Product Change Notification

Date Issued :	September 17, 2022	PCN Number :	512567
Reason for Change :	Change Supplier		
Description of Change :	This notification is to inform you about change of supplier impacting the part(s) attached as per list, No changes will be made to product as part of this change.		
Reason for Short Notice :	Supplier Constraints		
Assessment of Change :	First Article Inspection		
Planned Implementation Date :	December 20, 2022		
Sample Availability Date:	October 02, 2022		
Internal Molex Qualification Date :	December 05, 2022		
Last date to request Samples by Customer :	November 30, 2022		
Traceability Code Markings / Date :	Date code

Product Picture

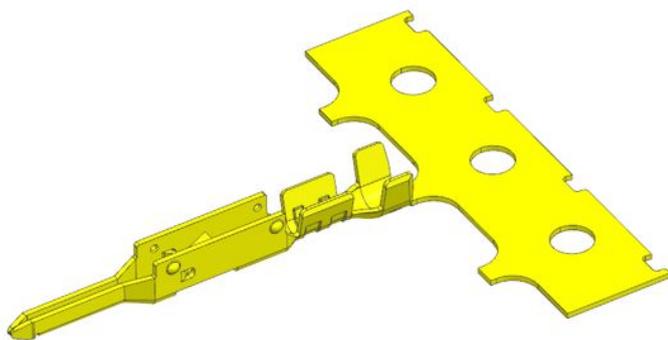
- Because current vendor Kemper stopped producing C19210 and C42500 metal alloy, we must qualify new source Boway to keep production running. Metal alloys are not changed. Boway is one of local metal supplier in China.
- Product Impact
 - no impact to fit, form or function
 - ✓ Before: C42500 WOP 0.200 X 22.00(HR06) P/N: 648971372
 - ✓ After: C42500 WOP 0.200 X 22.00(HR06) P/N: 648971372
- ✓ Product will be fully qualified before it is shipped. Qualification reports will be available after below listed date.
